CHANGE BULLETIN 01

F.G.A. No. 21003

ROOMS TO GO – OFFICE RENOVATION & EXPANSION

January 20, 2022

SHEET NUMBER
A2.01A

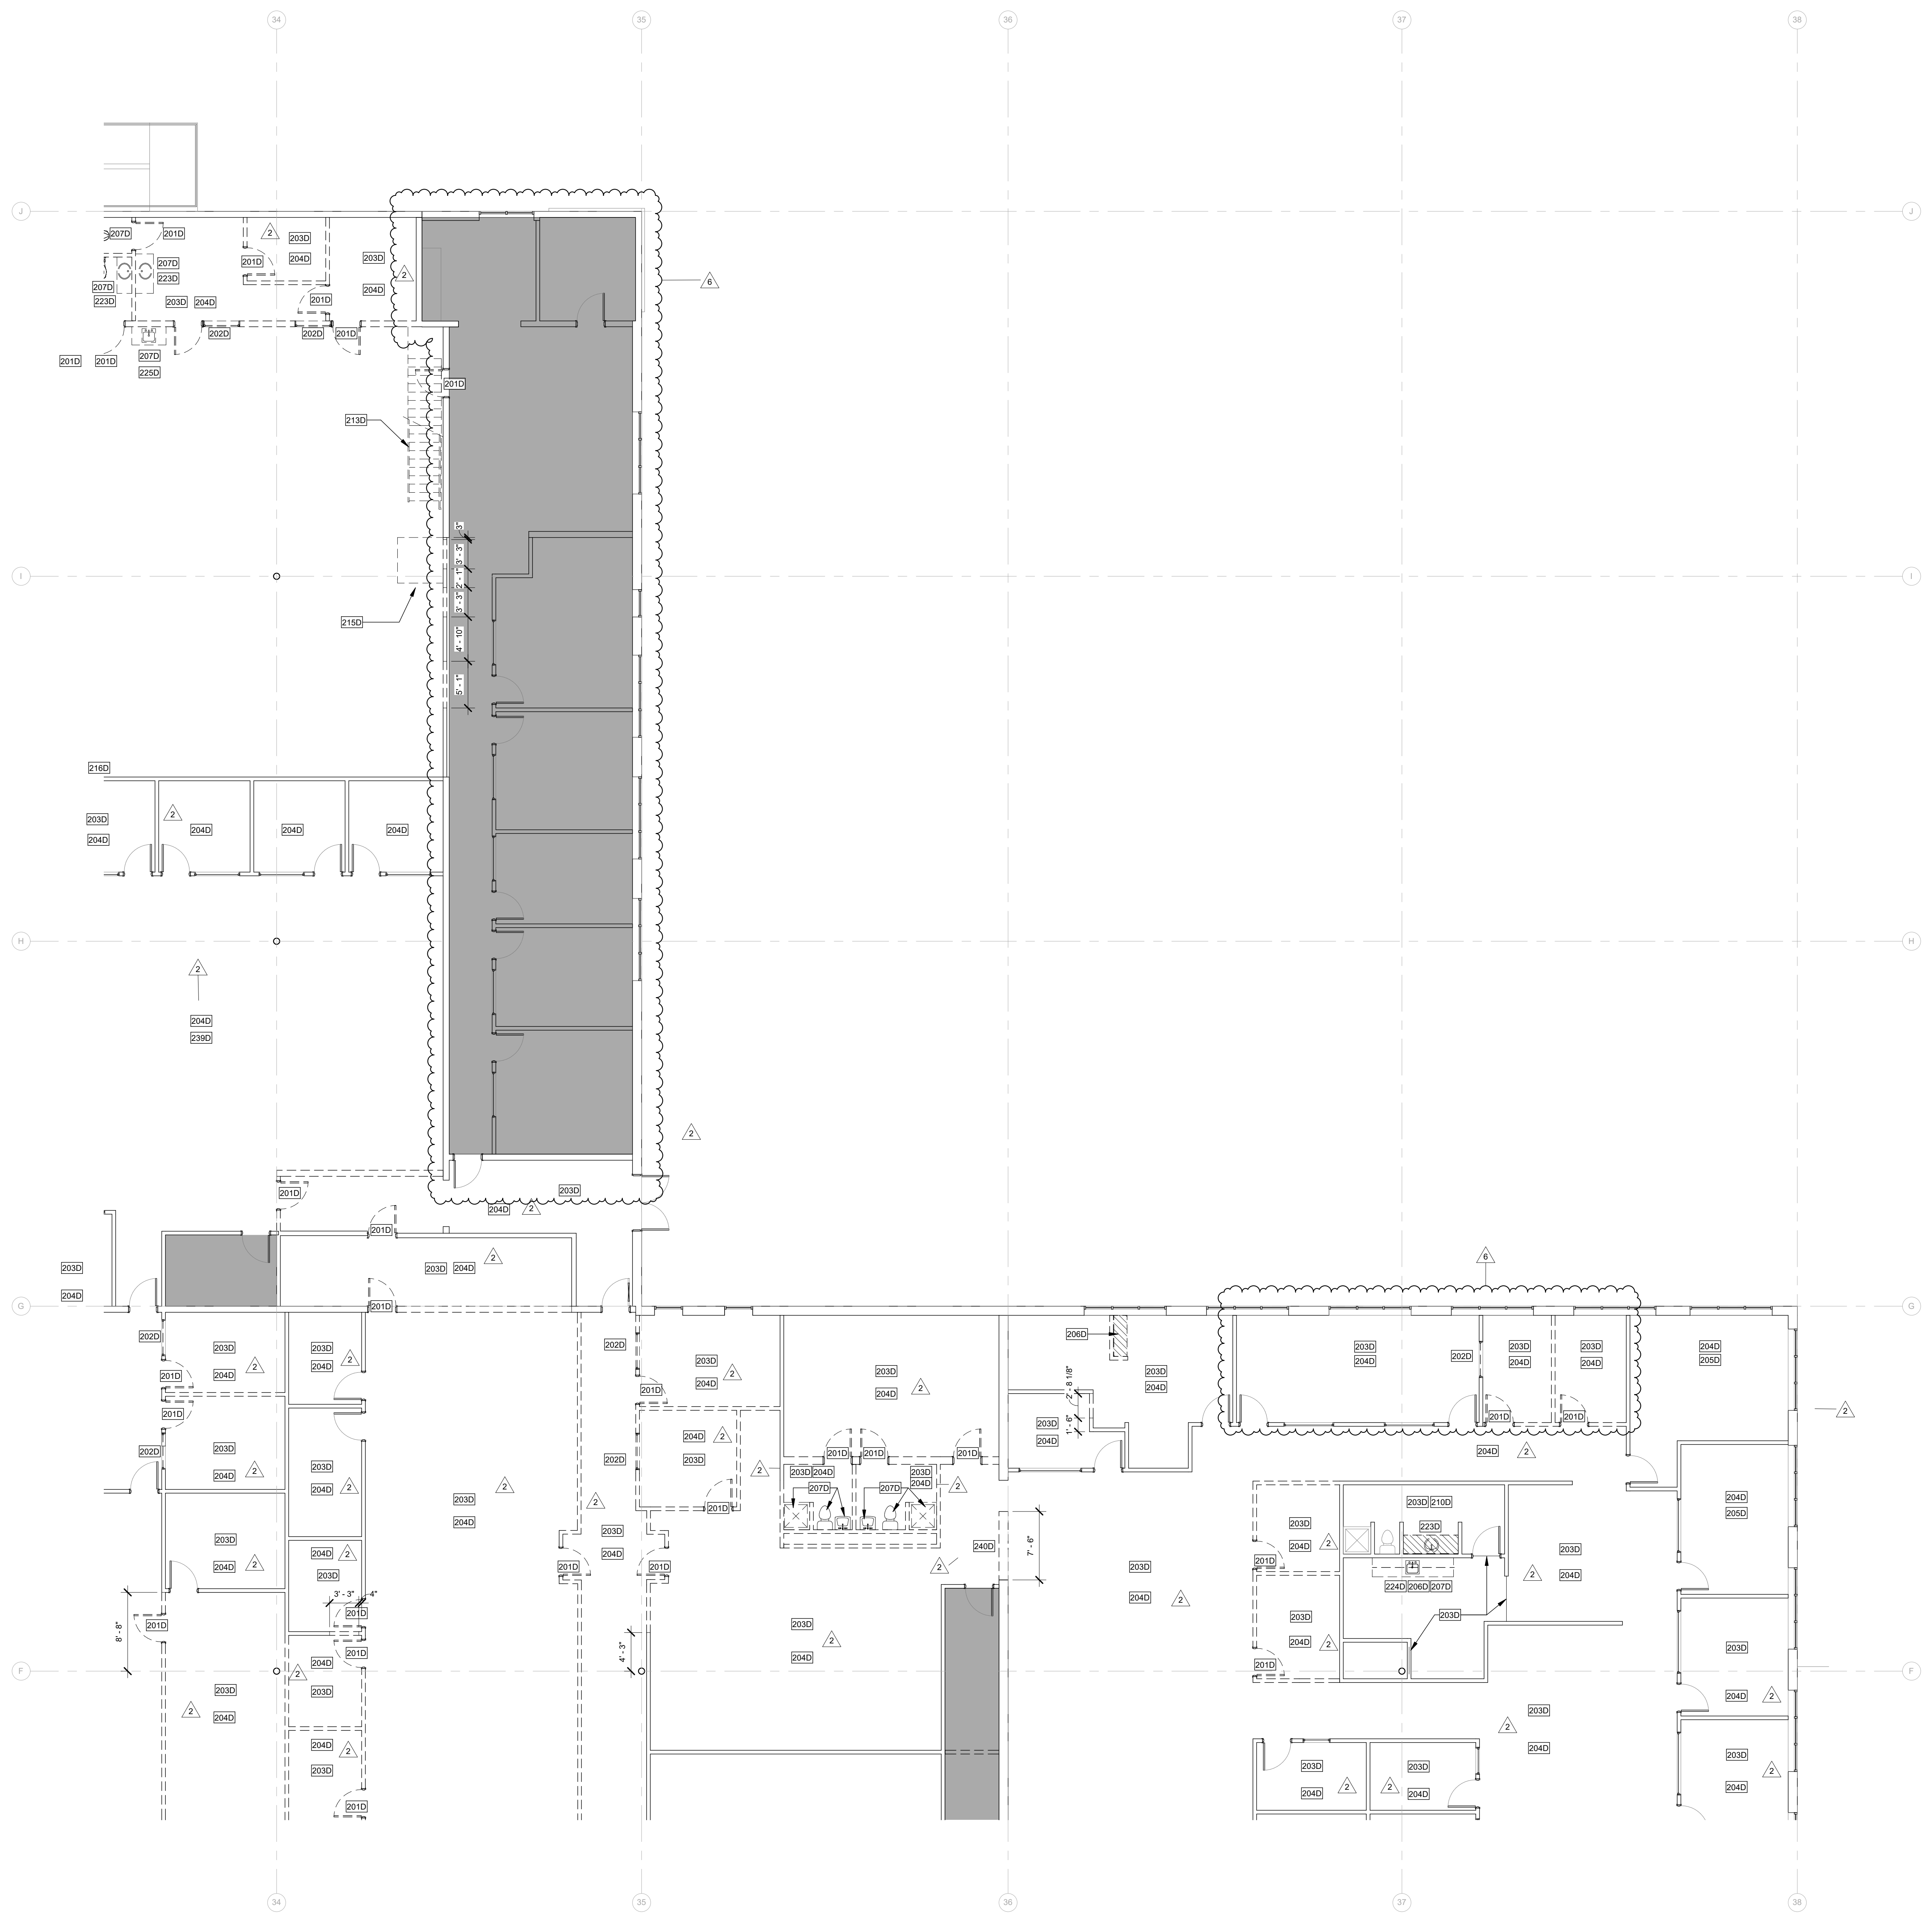
Item 3: Refer to Sheet A2.01A – Demolition Plan A
DEMO existing door A102. DEMO existing window in room A102 and infill with same materials and finish as adjacent construction.

SHEET NUMBER
A2.01C

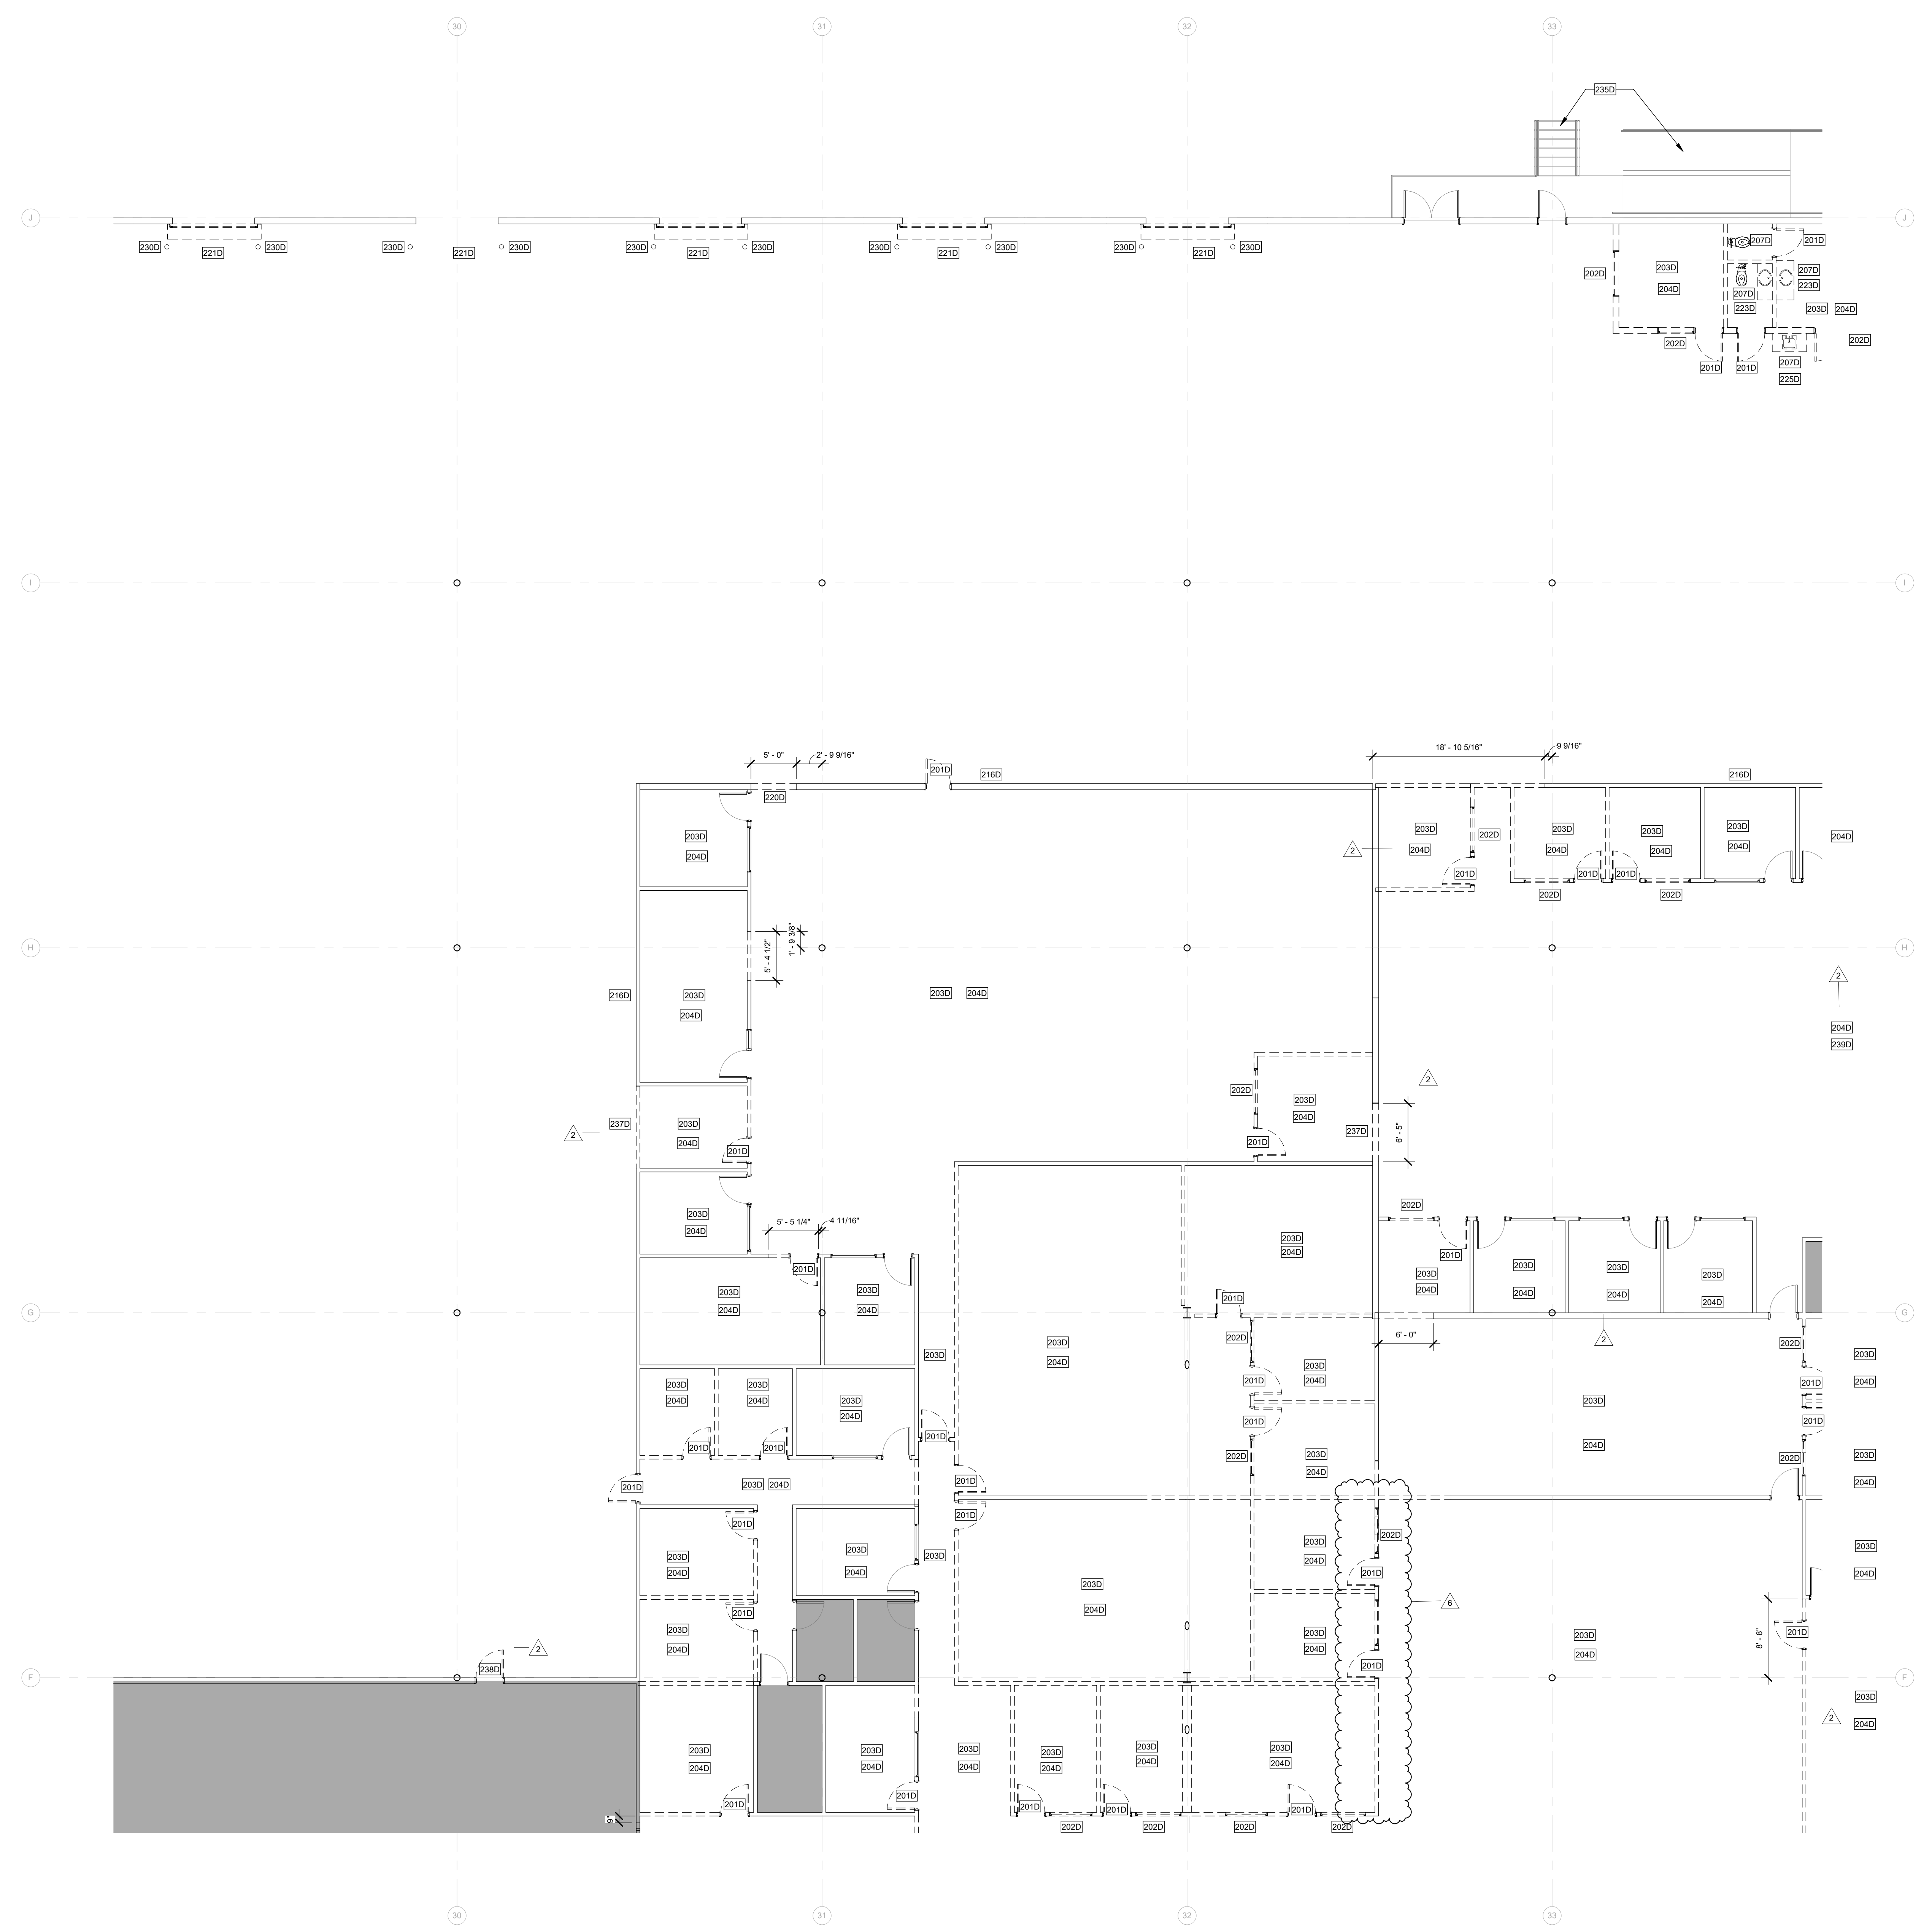
Item 4: Refer to Sheet A2.01C – Demolition Plan C
DEMO existing doors in offices C104 & C105. DEMO wall between offices C104 and C105. DEMO existing window in East wall of C113 and infill with same materials and finish as adjacent construction. REVISE south wall of Office C113 to show existing windows and doors to remain.

SHEET NUMBER
A2.01D

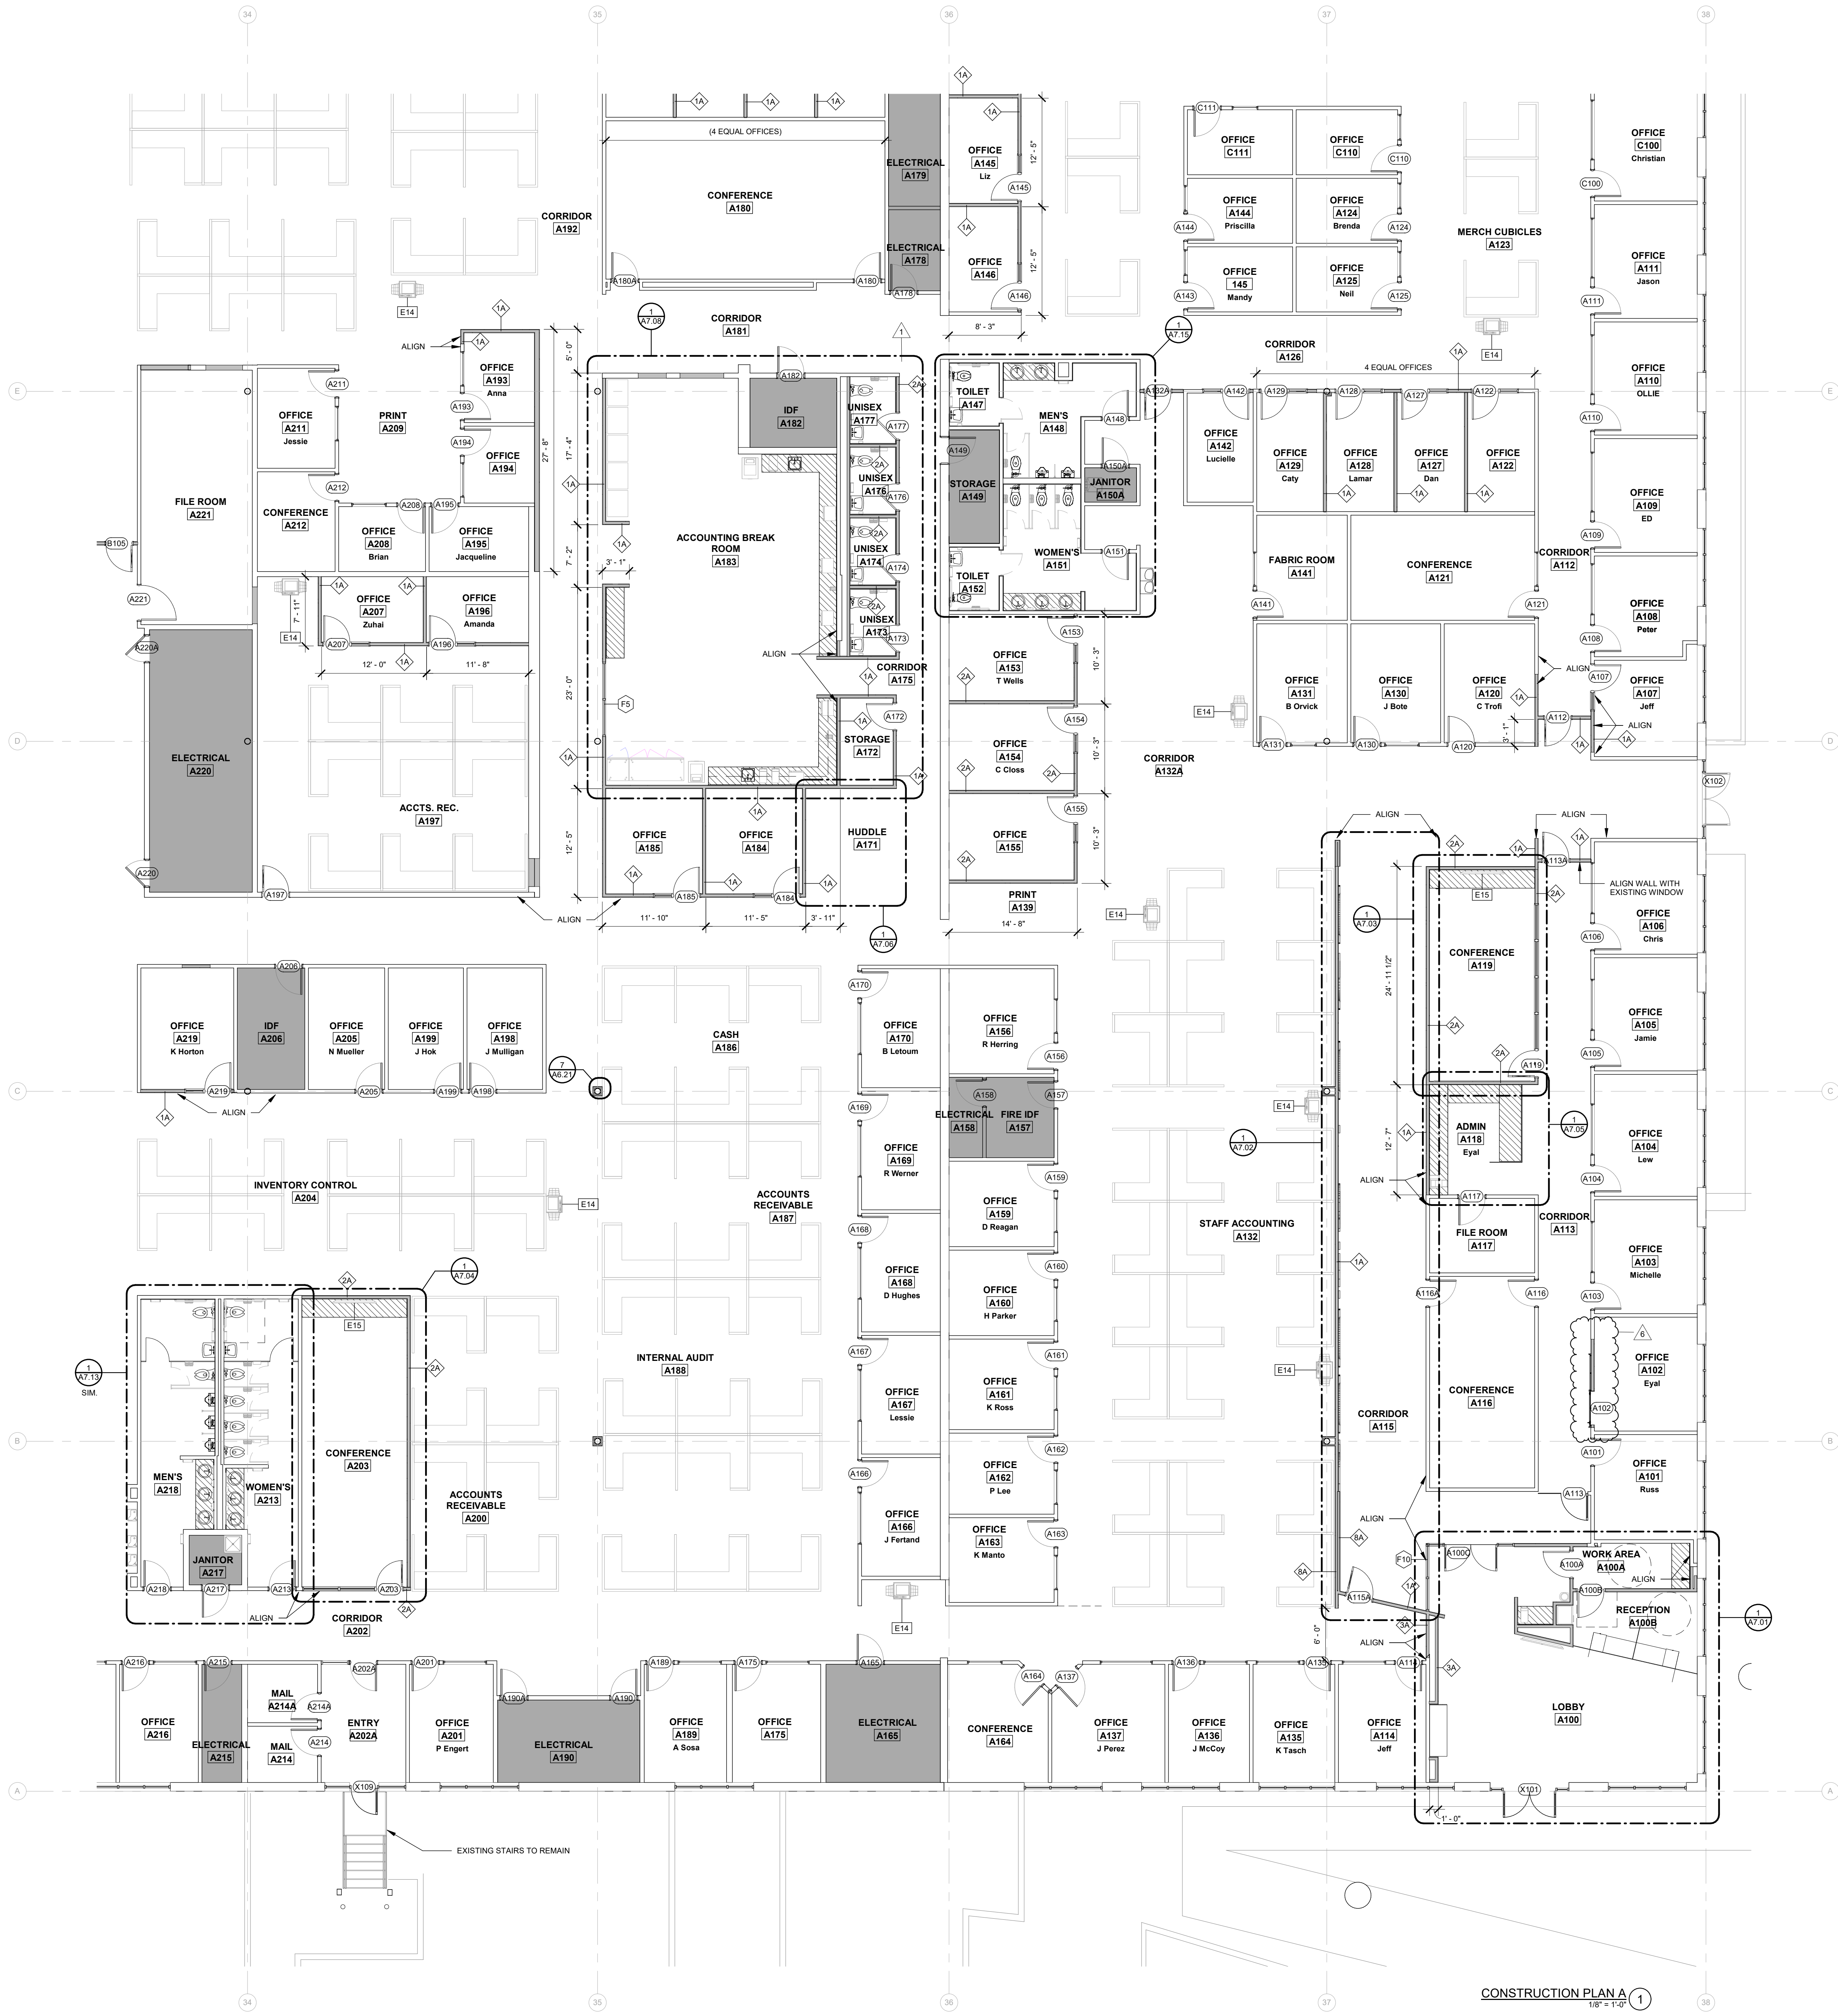
Item 5: Refer to Sheet A2.01D– Demolition Plan D
DEMO existing low wall between column lines 32 and 33.
